DRAWING NO. D212-664-141	TITLE XTUBE ASSY (205/212/412 HI FWD)	REV. D	DART AEROSPACE LTD ENGINEERING ORDER		D.E.O. NO. D212-664-141-D-1	SHEET NO. SHEET 1 OF 2	SCALE NTS
DRAWN	CHECKED	MFG. APPR.	APPROVED	DE APPR.			
DATE 11.04.07	DATE 11.04.11	DATE 11.04.12	DATE 11/04/12	DATE 11.04.12

ADD AN INSPECTION WINDOW TO UNDERSIDE OF CROSSTUBE.

DRAWING NO. D212-664-141	TITLE CROSSTUBE ASS'Y (205 HI FWD)	REV. D	DART AEROSPACE LTD ENGINEERING ORDER		D.E.O. NO. D212-664-141-D-2	SHEET NO. SHEET 1 OF 1	SCALE NTS
DRAWN <i>IR</i>	CHECKED <i>A>S</i>	MFG. APPR. <i>AS</i>	APPROVED <i>MD</i>	DE APPR. <i>HH</i>			
DATE 11.07.15	DATE 11.07.20	DATE 11.07.21	DATE 11/07/21	DATE 11.07.21

REPLACE MAGNOBOND WITH PROSEAL.

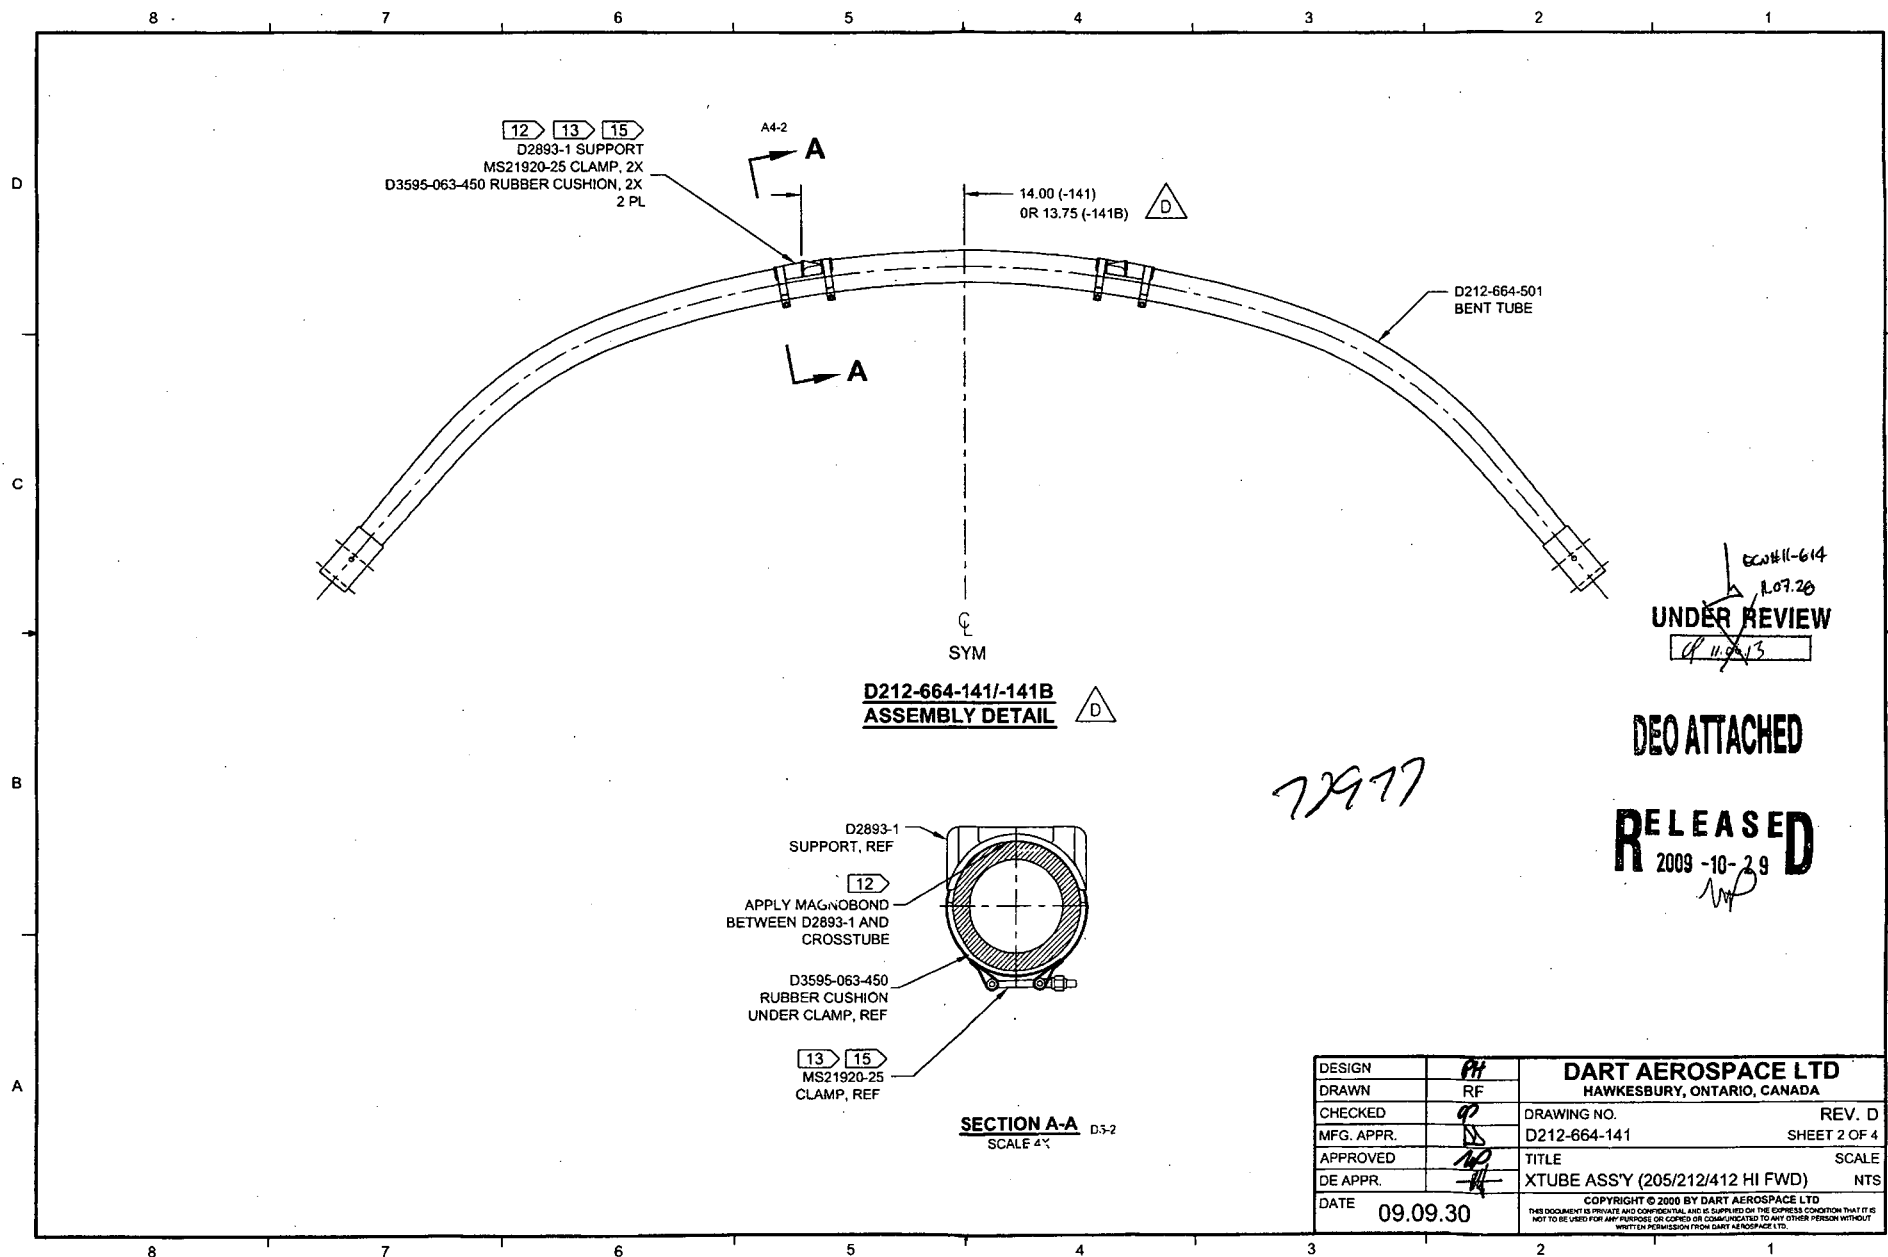
NOTE 12 & 15, SHEET 1 IS AMENDED AS FOLLOWS:

- 12) TO INSTALL D2893-1 SUPPORT: ABRASE MATING SURFACE OF SUPPORT AND CROSSTUBE WITH 180-GRIT SANDPAPER AND REMOVE RESIDUE WITH MEK (OR EQUIVALENT). APPLY A 0.04" TO 0.07" THICK LAYER OF PROSEAL 890 CLASS B-2 (OR AMS-S-8802 CLASS B-2) SEALANT TO MATING SURFACE OF SUPPORT.
- 15) TORQUE CLAMPS 80 TO 100 IN-LB. ENSURE AT LEAST 1.5 THREADS SHOWING IN SAFETY AND THAT NUT HAS NOT BOTTOMED-OUT AFTER TORQUING. PRIOR TO PACKAGING, RE-CHECK TORQUE ON CLAMPS AFTER PROSEAL 890 SEALANT HAS CURED FOR 72 HOURS.

- 12) INSTALL D2893-1 SUPPORT USING 0.03" TO 0.06" THICK LAYER OF MAGNOBOND 6398 TO THE SURFACE OF D2893-1 THAT WILL BE IN CONTACT WITH THE CROSSTUBE PER QSI 015. LET CURE FOR 12 HOURS AFTER INSTALLATION AND PRIOR TO PACKAGING.
- 15) TORQUE CLAMPS 80 TO 100 IN-LB. ENSURE AT LEAST 1.5 THREADS SHOWING IN SAFETY AND THAT NUT HAS NOT BOTTOMED-OUT AFTER TORQUING.

Item	Qty -141	Qty -141B	Part Number	Description
7	A/R	A/R	PROSEAL 890 B-2	SEALANT, AMS-S-8802 CLASS B-2

7	A/R	A/R	MAGNOBOND 6398	ROCKWELL SPECIFICATION RBO-120-023 ADHESIVE (TEXTRON/BELL SPEC. 299-947-100, TYPE II, CLASS 2 ADHESIVE)
---	-----	-----	----------------	---

**D212-664-141/-141B
ASSEMBLY DETAIL**

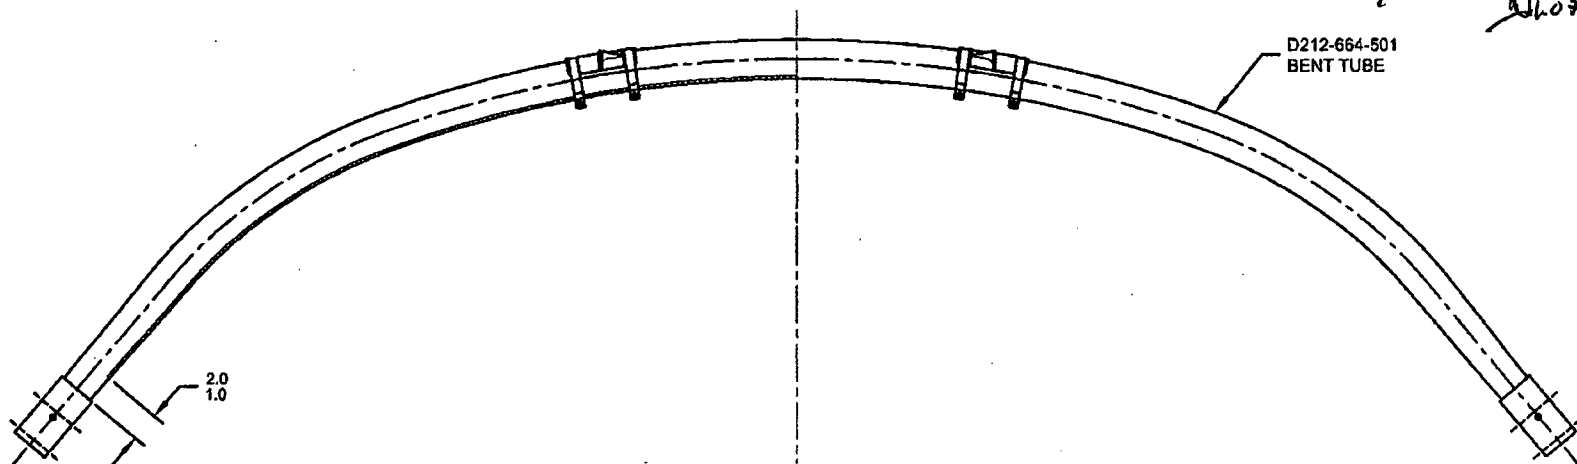
NOTES 2 OF SHEET 1 IS AMENDED AS FOLLOWS:

- 2) FINISH: CHEMICAL CONVERSION COAT PER DART QSI 005 4.1
PRIME INSIDE AND OUTSIDE PER DART QSI 005 4.2
MASK UNDERSIDE OF CROSSTUBE AS SHOWN (HATCHED AREA) AND
PAINT OUTSIDE PER DART QSI 005 4.2
REMOVE MASKING AND APPLY CLEAR COAT

- 2) FINISH: CHEMICAL CONVERSION COAT PER DART QSI 005 4.1
PRIME INSIDE AND OUTSIDE PER DART QSI 005 4.2
PAINT OUTSIDE PER DART QSI 005 4.2

MASK AREA PRIOR TO PAINTING,
REMOVE MASKING AFTER PAINT
AND APPLY CLEAR COAT
